IEEE 802.1Q[™]-2018 Fault Reporting Issue

Marc Holness February 2023

Fault Notification Specification Issues/Deficiencies

Subclause 20.37 MEP Fault Notification Generator state machine

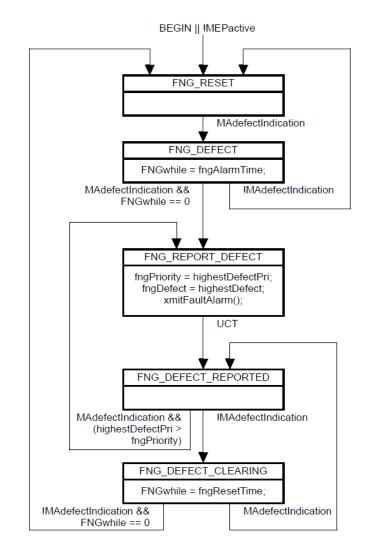
1. Lower priority fault notifications are not suppressed when a higher priority fault notification is generated

- At t0, priority 3 fault becomes active on the system
 - The notification for priority 3 fault gets generated
 - Fault-Present variable is set to TRUE
- At t1, a priority 5 fault arrives on the service
 - The notification for priority 5 fault gets generated
 - Fault-Present variable continues to be TRUE
- No CLEAR notification is seen for the lower priority fault (priority 3), as the system is tracking all the faults through one variable Fault-Present

- 2. Fault clear notification is not generated when multiple faults are present on a service
- 3. Fault notification is not generated for the new active fault, when multiple faults were present on a service and the highest priority fault present on that service gets cleared

- At t0, priority 4 fault becomes active on the system
 - The fault notification for priority 4 fault gets notified
 - Fault-Present variable is set to TRUE
- At t1, a priority 2 fault arrives on the service
 - Since, it has lower priority than the current active fault, no notification is generated
- At t2, fault of priority 4 clears from the service
 - This leaves priority 2 fault as the active fault on the service
- However, since there is no mechanism to track individual faults, the priority 4 fault's notification will not be cleared
- Additionally, no notification is generated for the current active fault (which is the priority 2 fault)

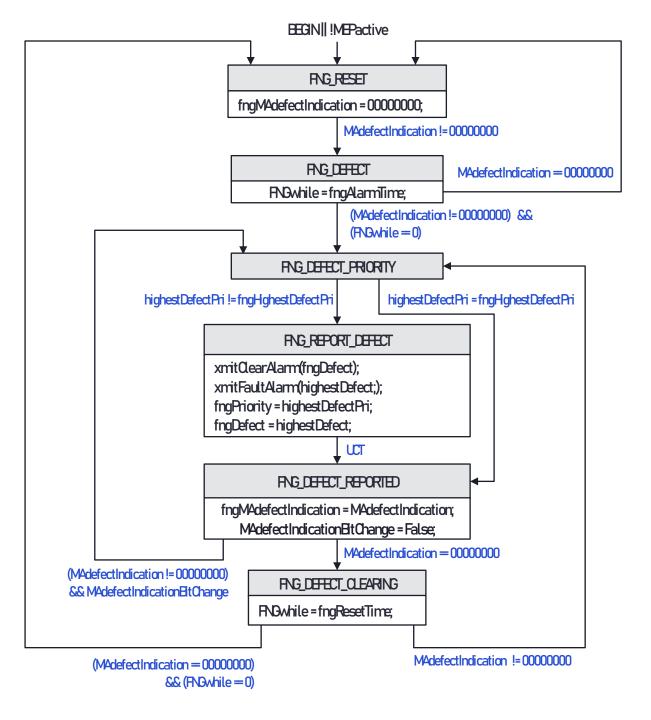
6. Introduce a new function called xmitClearAlarm()

"... This function transmits a Clear Alarm Notification. It takes fngDefect (20.35.2) as an argument. The identity of the MEP and the variable fngDefect (20.35.2), specifying the Fault Alarm that is cleared, and is transmitted in the Clear Alarm PDU ..."

7. Update the MEP Fault Notification Generator state machine as illustrated on next slide
